March 12, 2020

Product Change Notice - Screw length for entry door catches

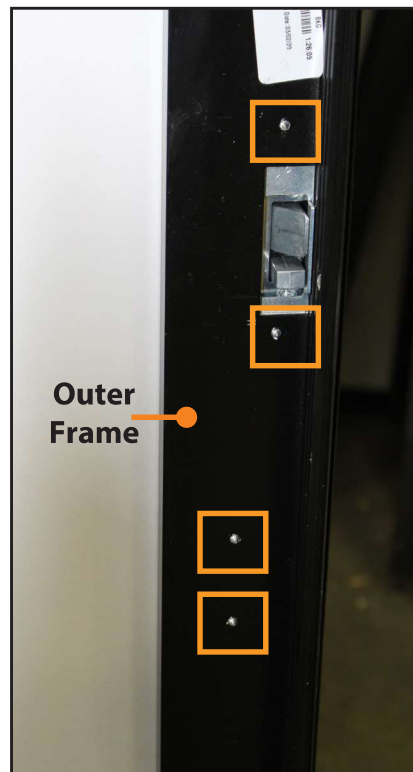
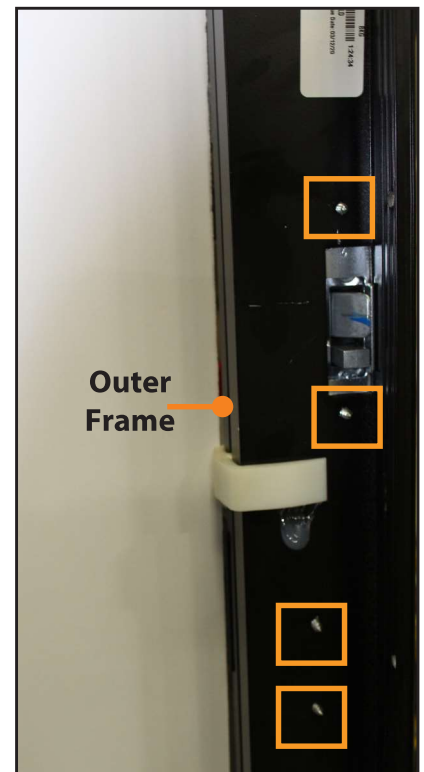
Please be advised LCI is changing the length on the screws for entry door strike plates and screen door catches from 1/4" to 3/8".

We determined increasing the thread engagement to the strike plate and catches will reduce the possibility of the screws stripping and becoming loose after heavy door usage over time.

Current screws marked with orange squares.

New screws marked with orange squares.

There is no change in fit, form, function or installation of the door with the new 3/8" screws. There is also no price change. The change is starting immediately.
